Access Compliance Report

Public Rights-of-Way

Intersection ID: 53124	Main Street: SHARON_VIEW_RD	Cross Street: CALVET_CT	Location: N
ADA ID: 22FBAEEEFBA4	Ramp Type: PerpDiag	Initial Pass/Fail: Fail	Overall Compliance: No
			Severity Score: 13.75

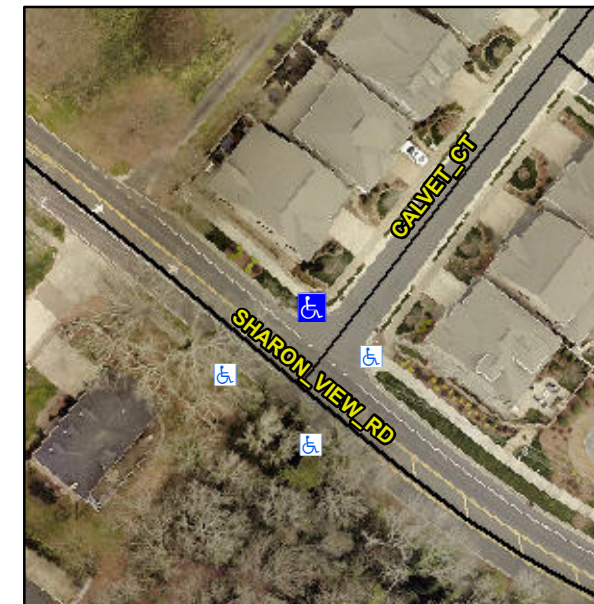
Not Found, R304.2.2, R304.5.3

Compliance	Description	Data	Compliance	Description	Data
N/A	Ramp Length (in)	53.5	No	Ramp Slope (%)	9.1
Yes	Ramp Width (in)	48.0	No	Ramp XSlope (%)	3.1
N/A	Flare Type LT	N/A	N/A	Flare Type RT	N/A
N/A	Flare Slope LT (%)	N/A	N/A	Flare Slope RT (%)	N/A
N/A	Flare Traversable LT?	N/A	N/A	Flare Traversable RT?	N/A
N/A	Landing Length (in)	N/A	N/A	DWS Provided?	N/A
N/A	Landing Width (in)	N/A	N/A	DWS Contrast?	N/A
N/A	Landing Slope (%)	N/A	N/A	DWS Length (in)	N/A
N/A	Landing X Slope (%)	N/A	N/A	DWS Full Width?	N/A
N/A	Landing Curb? (Y/N)	N/A	N/A	DWS Offset (in)	N/A
N/A	Shared Landing?	N/A			
N/A	Gutter Ponding?	N/A	N/A	Gutter Slope (%)	N/A
N/A	Gutter Lip Ht (in)	N/A	N/A	Gutter X Slope (%)	N/A
N/A	Painted X Walk1?	No	N/A	Painted X Walk2?	No
	X Walk 1 Direction	To SW		X Walk 2 Direction	To SE
N/A	X Walk 1 Width (in)	N/A	N/A	X Walk 2 Width (in)	N/A
	X Walk 1 Slope (%)	1.7		X Walk 2 Slope (%)	1.4
	X Walk 1 X Slope (%)	3.3		X Walk 2 X Slope (%)	0.6

Remove & Replace Curb Ramp With Two New Directional Ramps or Equivalent.
